General machining tolerances UNI 5307-63								
Dimensions	< 6	= 6-30	> 30-120	> 120-315	> 315-1000	> 1000-2000	> 2000-4000	> 4000
Linear Toli.	± 0.1	± 0.2	± 0.3	± 0.5	± 0.8	± 1.2	± 2	± 3
angular Toli.	± 1'	± 30'	± 20'	referred to the shortest side				
designed for						R.De Salvo		
LIGO PROJECT						draw. by G. Gennaro-PROME		
title						date		
HAM-OPTICAL BENCH						9-01-05		
INVERTED PENDULUM						scale		
						1/2		
						LIGO-D051138-03-D		
						detail		
						107		
						A 2

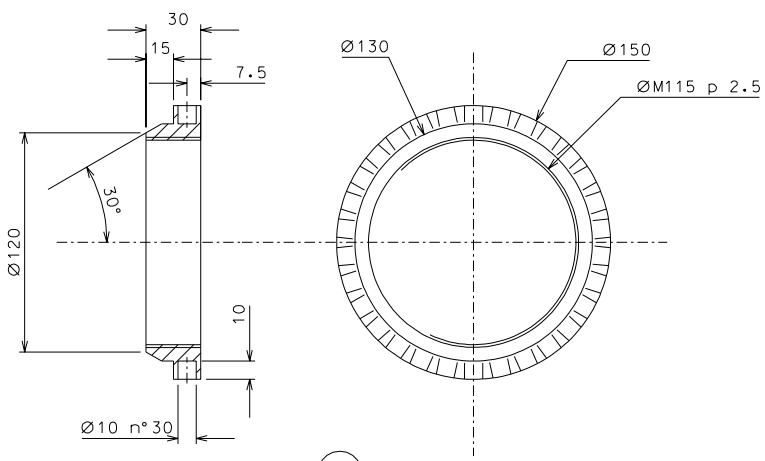
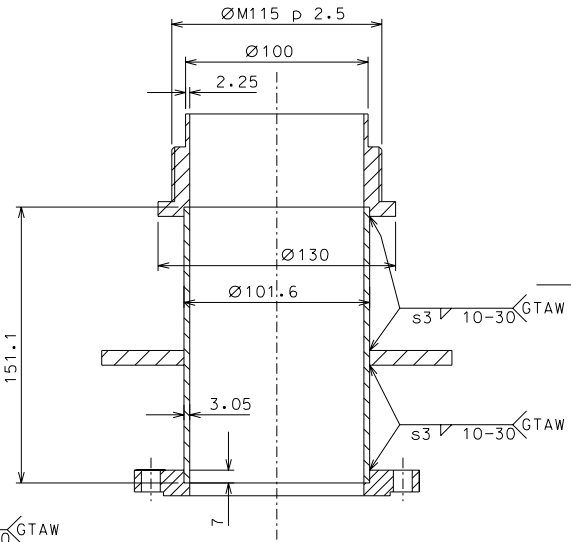
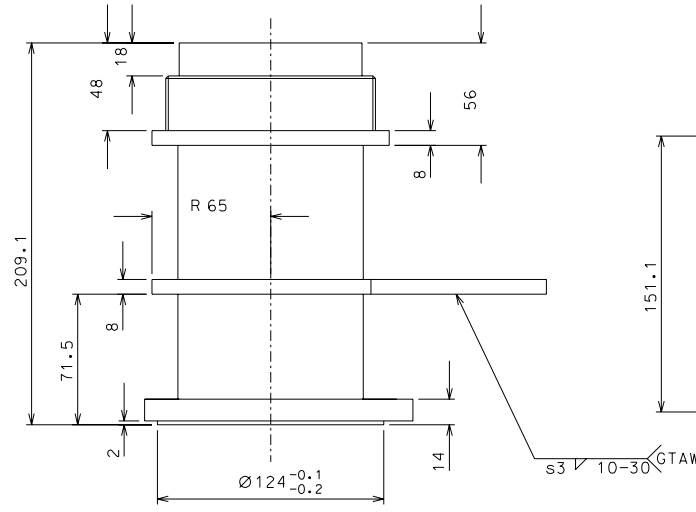
changed material part 33		17-08-06	
modified part 32		19-06-06	
added dimension		07-04-06	
ref.	note	date	signature
modifications			
71	2	AISI 304	1/2
33	4	AISI 304	1/2
32	4	AISI 304 L	1/2
ref.	pieces	mat. and treatments	scale
